ADDENDUM NUMBER ONE

RE-BID: NEW LANDSCAPING AT USC UPSTATE PUBLIC SAFETY BUILDING
PROJECT# CP00362344
UNIVERSITY OF SOUTH CAROLINA UPSTATE
SPARTANBURG, SOUTH CAROLINA

DATE OF ISSUE: FEBRUARY 14, 2013

TREE PLANTING DETAIL

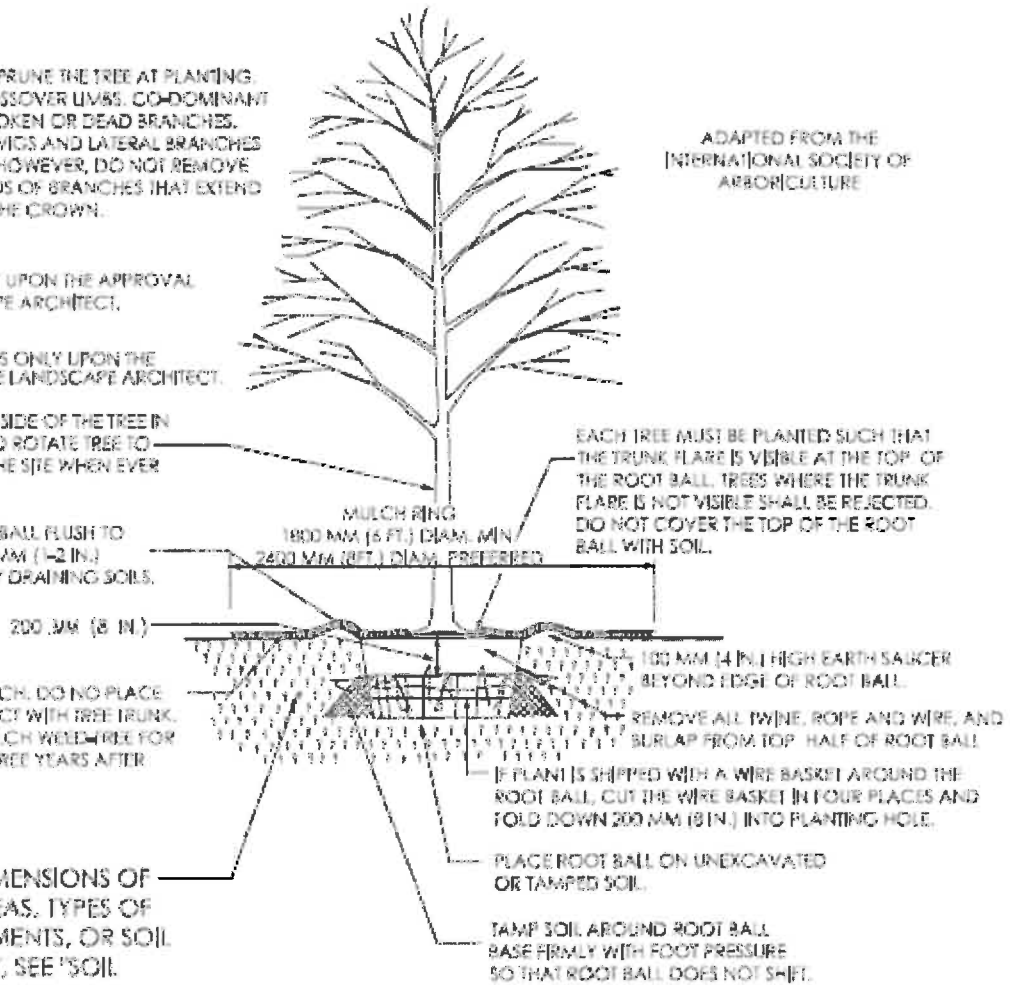
| 3. | See attached tree and shrub planting detail. (2 Pages) |

4. Question: Is there any requirement for the Trees to be staked and guyed? Answer: No staking or guying required.
5. Question: Will the contractor be responsible for bidding the cost of having the water company install the water meter? Answer: Yes

STAKE TREES ONLY UPON THE APPROVAL OF THE LANDSCAPE ARCHITECT.

WRAP TREE TRUNKS ONLY UPON THE APPROVAL OF THE LANDSCAPE ARCHITECT.
